Comment on Mount Iron Junction Fast-Track Application

Pete Barham & Lisa McFarlane

Figure 1 - Section of highway showing informal passing areas
(Image from Google Maps)

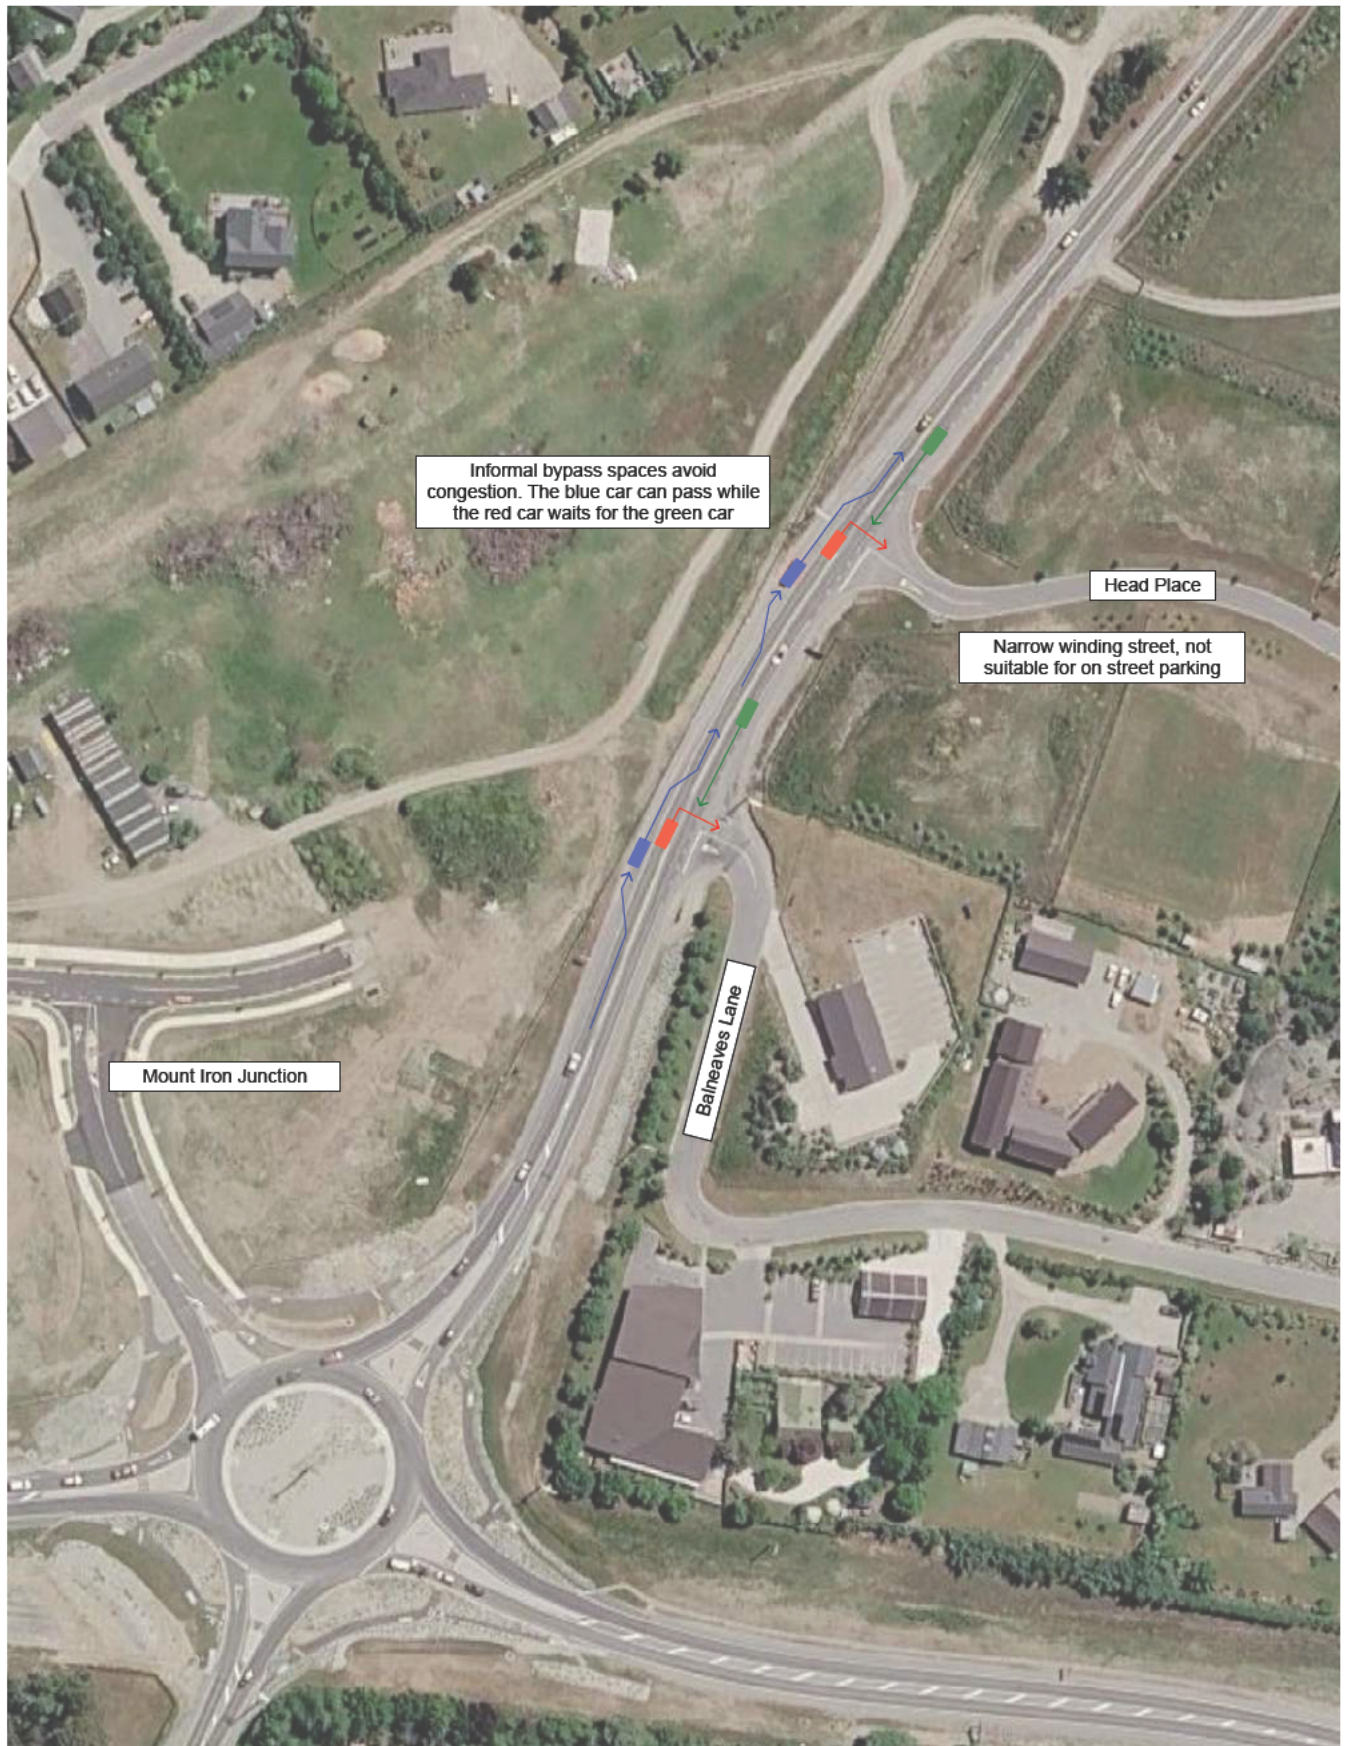
We live on Head Place, which accesses the Albert Town Lake Hawea Road opposite the Mount Iron Junction Site. When turning into Head Place from the roundabout, we often have to wait for vehicles driving south from Albert Town before we can turn into Head Place. Currently this is of no concern as there is an informal passing space between the road and the Mount Iron Junction site, for northbound vehicles to pass.

Our concern with overcrowding of vehicles (as mentioned above) is that vehicles will park in this informal passing space, leading to northbound vehicles backing up behind us while we wait to turn in, congesting the roundabout. The issue isn't new vehicle movements created, but existing vehicles being delayed due to additional parking demand spilling beyond the development site, affecting already tight access to Head Place.

See **Figure 1** attached for visual description of our concern.

- Formalising this passing area or adding yellow 'No Parking' lines.

Figure 2 - Areas with minimal planting to screen larger buildings
(Images from Appendix D3 pages 10 & 11)

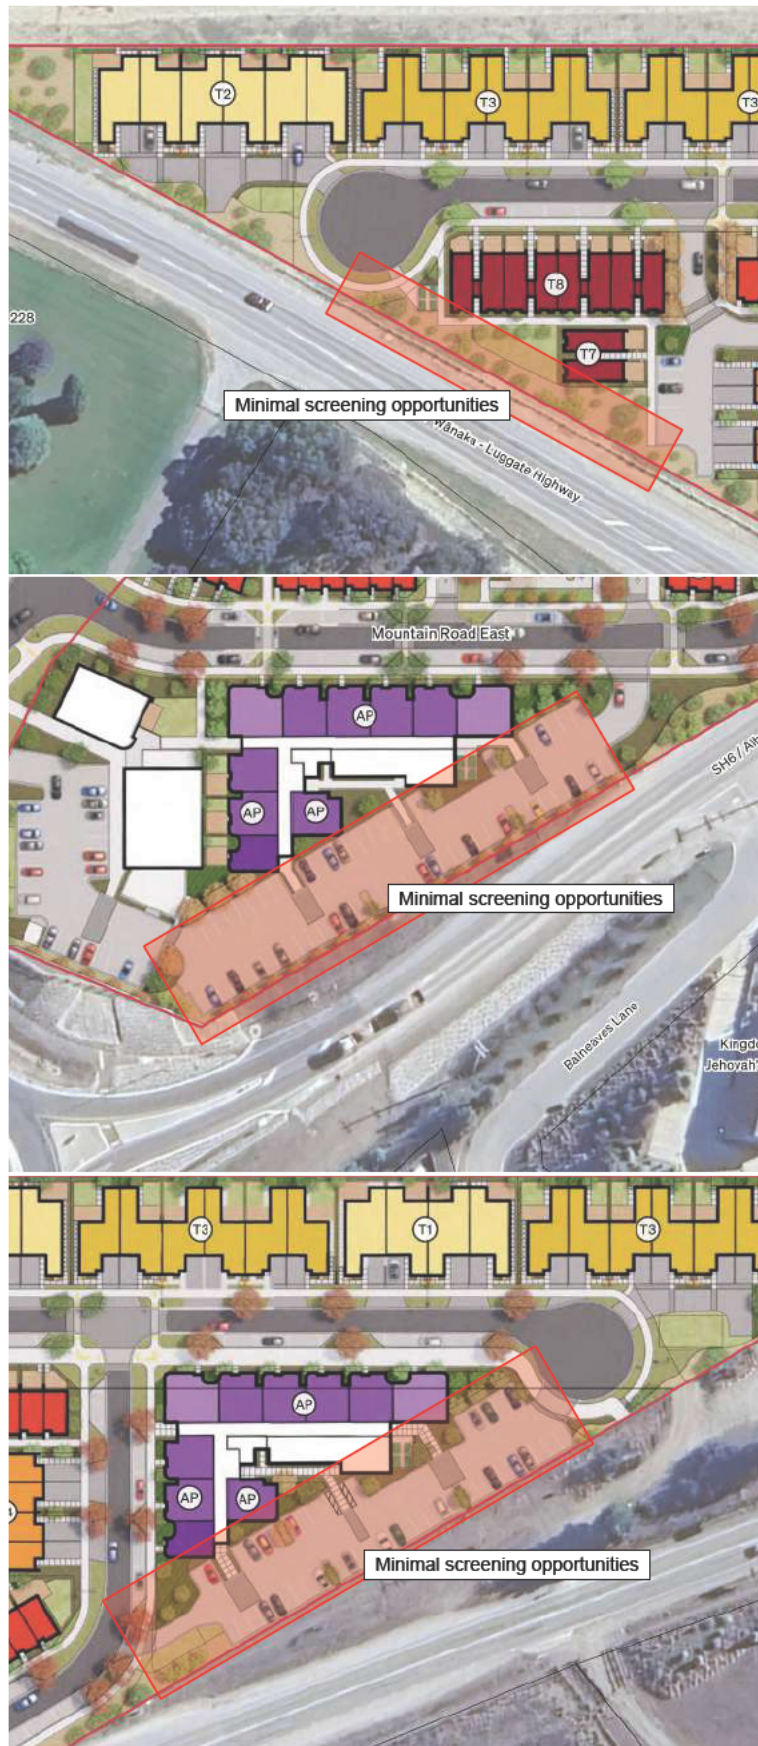
- The building height for Apartment Blocks 22 & 33 (10m as noted on Appendix C1 sheet A1.62) represents a substantial increase in built form compared to the surrounding environment. Given the location adjacent to major public roads (and minimal landscaping between) these buildings are likely to become dominant visual elements in this area. This is at odds with what would be expected in a rural area, as evidenced in the surrounding environment.

- Blocks 3 & 4 are also significant in height (8.99m as noted on Appendix C sheet A1.14) and very close to the Wanaka Luggate Highway, again at odds with the surrounding environment.

See **Figure 2** attached for referenced areas of minimal planting.

- **Further assessment** - We note no height markers are present on site for any of the development, it would be useful to see height markers for at least blocks 3, 4, 22 & 33. This would help assess concerns around the height and position of these larger blocks.
- Enforcing rural setbacks to the roads (20m) to retain the rural character of the area.
- Enforcing maximum building height (8m) to reduce the visual impact of the development, especially where close to the roads.
- Enforcing rural setbacks to the internal boundary with Old Racecourse Road properties (15m), or at a minimum provide Large Lot Residential A setbacks (4m) as that is the zoning of those neighbouring properties.
- Adding increased planting between the development and the surrounding roads to minimise the visual impact of the development.
